Planning Committee Meeting Thursday 7 November 2019

- 5 **LATE [PR-PC] Development Application DA19/0683 for the Construction of the New Tweed Valley Hospital (NSW Planning & Environment App No. SSD 10353) and DA18/0685.01 Modification to the Concept Plan (NSW Planning & Environment App No. SSD 9575) at Lot 11 DP 1246853 No. 771 Cudgen Road, Cudgen**

On Thursday 3 October 2019 Council received copies of the Stage 2 State Significant Development Main Works and Operation application for Tweed Valley Hospital (SSD10353) with a concurrent modification to the already approved Concept Plan (SSD 9575).

That Council in regard to Development Application DA19/0683 for the construction of the new Tweed Valley Hospital (NSW Planning & Environment App No. SSD 10353) and DA18/0685.01 Modification to the Concept Plan (NSW Planning & Environment App No. SSD 9575) at Lot 11 DP 1246853 No. 771 Cudgen Road, Cudgen endorse the Draft Council Submission at Attachment 1.

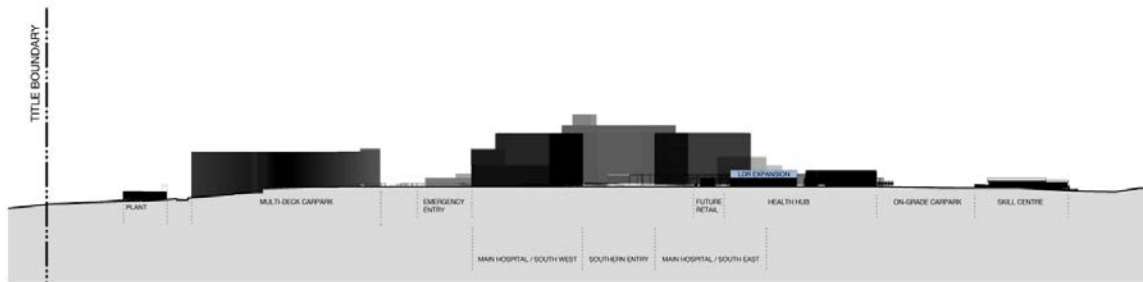
The main element of the modification that Council wants the Department to further investigate is the introduction of the 10 storey multi deck car park on the western side of the development site. This will be the first element of the site for anyone visiting the Hospital from the main Tweed Coast Road and M1 Highway. To date the application has not demonstrated a western photomontage of the multi deck car parking area or suggested sufficient mitigation measures to soften the impact of this structure. The multi-deck car park appears to represent a solution for onsite parking however it could be better incorporated to the site with softer design elements (green walls), an air bridge connecting to the main hospital, and further site consideration for additional covered awnings throughout the site.

From an agricultural perspective the main concern with the multi-deck car park is that it will remove the opportunity to increase the western boundary vegetation buffer should intensive agriculture occur in the future on the parcel to the west. The proponent should be providing some form of additional screening in that side of the car park. The car park itself probably provides some additional screening to the hospital but even users of the car park can be a sensitive receiver. The largest changes from these modifications appear to affect the built form and urban design with two new building envelopes shown below in site plan version and elevation version. The first near Cudgen Road is a smaller building for a skills centre associated with the TAFE NSW and the second is the 10 storey multi deck car park:

3 CUDGEN ROAD ELEVATION
Elevation 1 : 1250

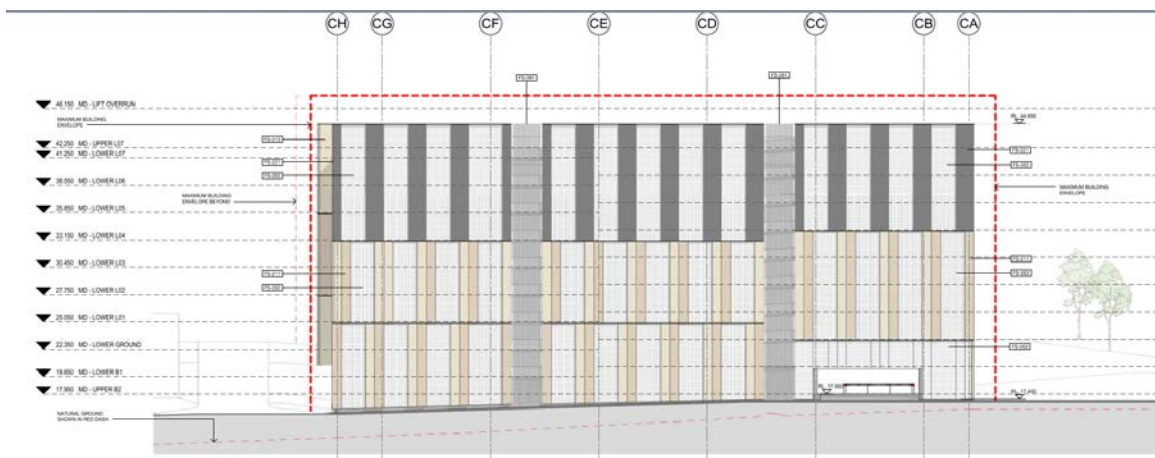
The quadrant floor plate configuration of the upper levels would open up floor plates to multiple view and natural light opportunities, there is also a significant western and south western elevation surface area which would be subject to significant heat load. The relative flat elevation finish would provide little shading opportunity.

- *Greater diversity in elevation articulation and material finish. This could include more layered and or screened elevations relating to solar orientation aimed at reducing heat loads on elevations which would also introduce an additional layer of design detail;*
- *Exploration of a stronger horizontal rather than vertical elevation composition to further break down the buildings overall mass, scale and height and more fully explore the topographic and landscape relationship between the site and building. This could include cantilevering floor plate edges to create shaded overhangs and further articulation of the glazed facades transom and mullion configuration;*

GENERAL ARRANGEMENT PLAN
LEVEL 01

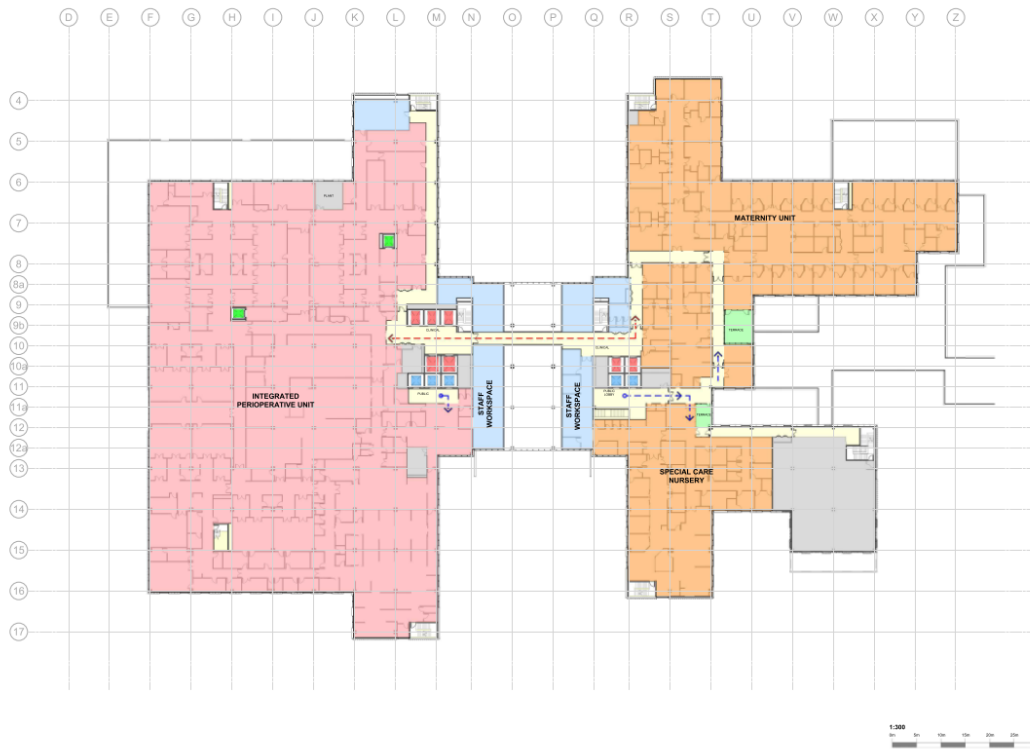
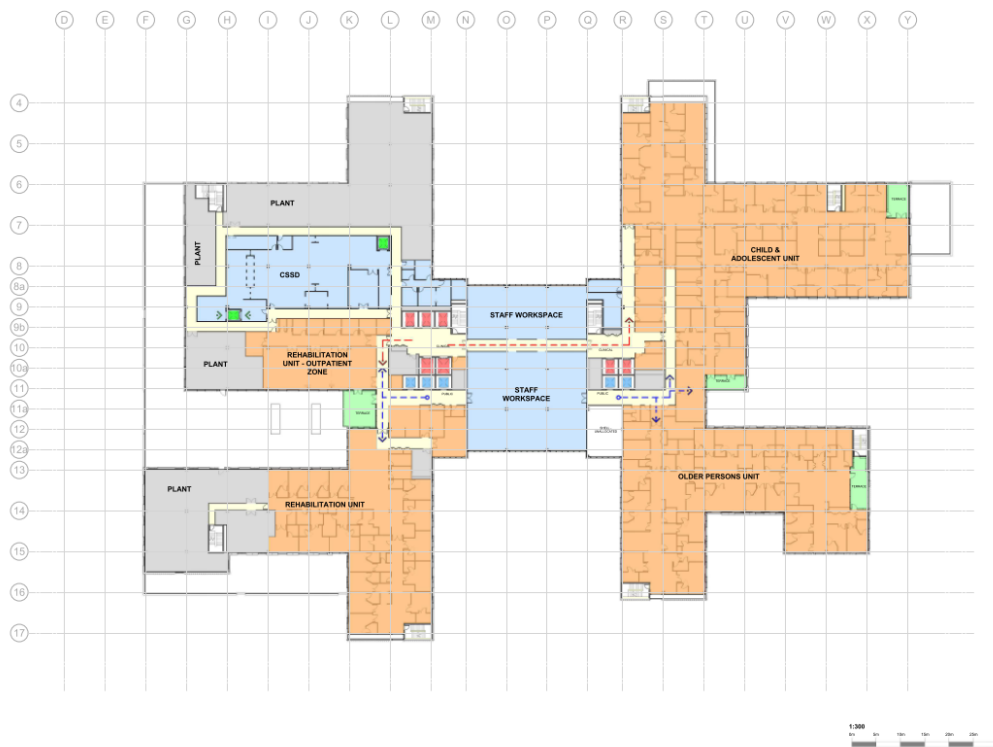
It is also noted that on some floor plates (ground, level 02, level 03) service plant areas have been nominated to the north / north-eastern edges of the building which would have the optimum opportunities for solar aspect and views towards the ocean.

Figure 5.2: Tweed Coast Road / Cudgen Road – Upgrade Works

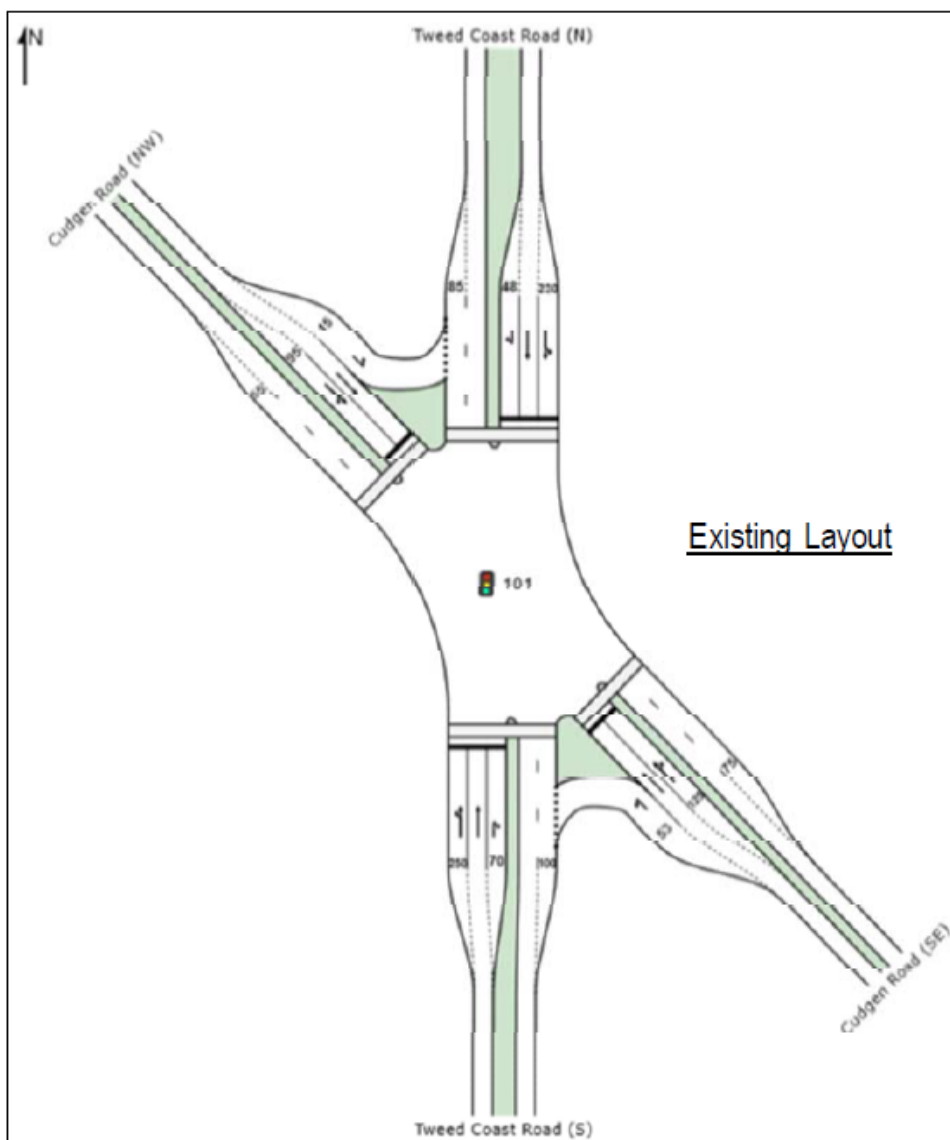
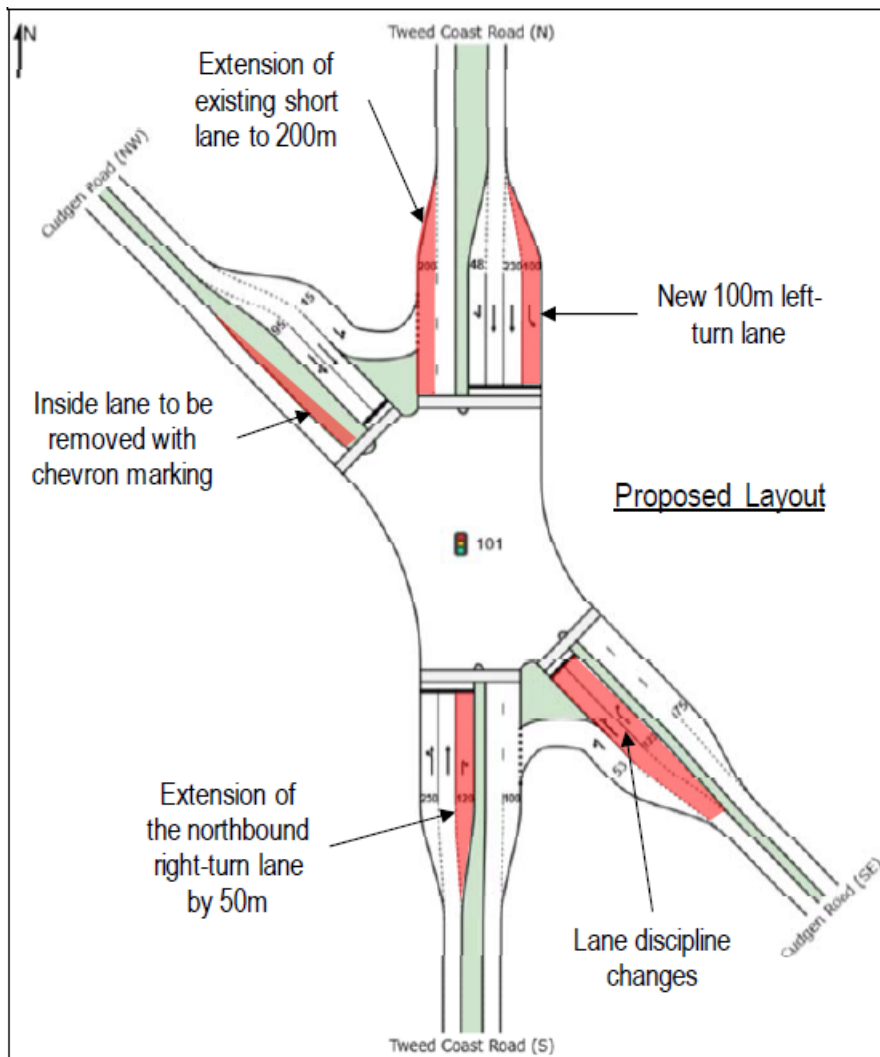
The proposed intersection upgrades are generally acceptable, given they were initially proposed as part of Council's Tweed Road Development Strategy.

At a meeting held between Council staff and the hospital project team on 21 October 2019, the potential to undertake additional infrastructure works at this intersection in conjunction with the hospital works was discussed. A 500mm sewer rising main is required through the intersection to connect the future Kings Forest development to the south to the Chinderah Waste Water Treatment Plant to the north. A significant upgrade to a transverse stormwater drain north of the intersection is also required, and has been discussed with consultants for Gales Holdings to facilitate residential development in Cudgen/West Kingscliff.
